FOUNDATION INVESTIGATION REPORT
for
Proposed Subway Hwy. #2 & C.P.R.
Newcastle
District #7 (Port Hope)
M.J. 67-P-73 -- M.P. 50-65-1

FOUNDATION INVESTIGATION REPORT
for
Proposed Subway Hwy. #2 & C.P.R.
Newcastle
District #7 (Port Hope)
W.J. 67-P-73 -- W.P. 50-65

-- C.P.R. Subway at Newcastle --
Hwy. #2 - District #7 (Port Hope)
W.P. 50-65 - Site 21-190 - W.J. 67-P-72

We have reviewed the Preliminary Bridge Plan Drawing D-6367-P2 for the above mentioned structure, and submit the following comments:

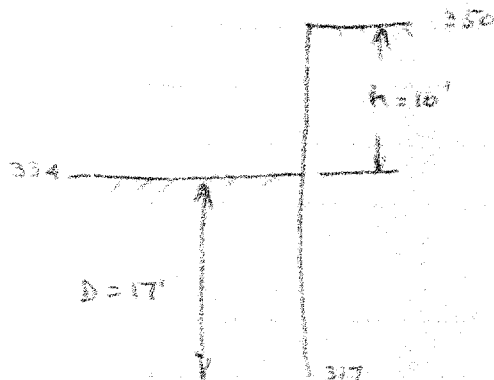
Sheet piling will be driven to allow excavation for south half of structure

Railroad grade is $348 \pm$

Bottom of stage I excavation will be @ $334 \pm$

Sheet piling will be driven $20'$ below

top of fill i.e. $337 - 20 = 317 \pm$ ($337 =$ top of fill (abutment) or top of pile cap for here).

Fill material for this embankment extends to about elevation $310 - 315$. Piling will be in fill.

$$D/h = 0.87 \therefore D = 16 \times 0.87 = 13.9' \approx 14' \therefore$$

depth of penetration adequate.

$$f_{max} = \frac{M_{max}}{S} = \frac{43,520 \times 12}{48} = 11,000 \text{ psi} < 20,000$$

:- ok
